Access Compliance Report

Public Rights-of-Way

Intersection ID: 32303	Main Street: EMPIRE_WOODS_CT	Cross Street: TRAVIS_GULCH_DR	Location: NW
ADA ID: 082DABFEBA23	Ramp Type: Perp	Initial Pass/Fail: Fail	Overall Compliance: No
			Severity Score: 13.75

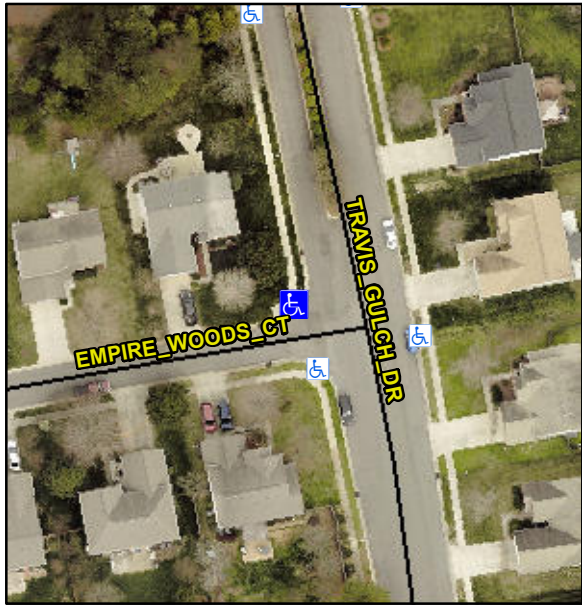
Codes/Mitigation Info/Possible Solution			Field Measurements/Component Compliance					
	Possible Solutions:		Compliance	Description	Data	Compliance	Description	Data
	Remove & Replace Entire Ramp.		N/A	Ramp Length (in)	47.0	No	Ramp Slope (%)	8.7
			Yes	Ramp Width (in)	61.0	No	Ramp XSlope (%)	2.5
			N/A	Flare Type LT	N/A	N/A	Flare Type RT	N/A
			N/A	Flare Slope LT (%)	N/A	N/A	Flare Slope RT (%)	N/A
			N/A	Flare Traversable LT?	N/A	N/A	Flare Traversable RT?	N/A
			N/A	Landing Length (in)	N/A	N/A	DWS Provided?	N/A
			N/A	Landing Width (in)	N/A	N/A	DWS Contrast?	N/A
			N/A	Landing Slope (%)	N/A	N/A	DWS Length (in)	N/A
			N/A	Landing X Slope (%)	N/A	N/A	DWS Full Width?	N/A
Surveyor Notes:		N/A	N/A	Landing Curb? (Y/N)	N/A	N/A	DWS Offset (in)	N/A
PROW/ADA:		Not Found, R304.2.2, R304.5.3	N/A	Shared Landing?	N/A			
			N/A	Gutter Ponding?	N/A	N/A	Gutter Slope (%)	N/A
			N/A	Gutter Lip Ht (in)	N/A	N/A	Gutter X Slope (%)	N/A

N/A	Painted X Walk1?	No	N/A	Painted X Walk2?	N/A
				X Walk 1 Direction	To S		X Walk 2 Direction	N/A
			N/A	X Walk 1 Width (in)	N/A	N/A	X Walk 2 Width (in)	N/A
				X Walk 1 Slope (%)	0.3		X Walk 2 Slope (%)	N/A
				X Walk 1 X Slope (%)	3.4		X Walk 2 X Slope (%)	N/A
			N/A	Ramp inside XWalk1?	N/A	N/A	Ramp inside XWalk2?	N/A
				Road Slope (%)	N/A	N/A	Clear Space?	N/A
				Road X Slope (%)	N/A	N/A	Clear Space to XWalk (in)	N/A
			N/A	Any Obstructions?	N/A	N/A	Storm Grate/Utility Hazard?	N/A
				Obstruction Type			Storm Grate/Utility Type	
					N/A			N/A
						Yes	Surface Condition? (G/P)	Good
Street 1 Name		EMPIRE WOODS CT						
Stop Condition-Street 2		StopSign						
Street 2 Name		N/A						
Stop Condition-Street 1		N/A						
Total Cost:		\$ 1850.00
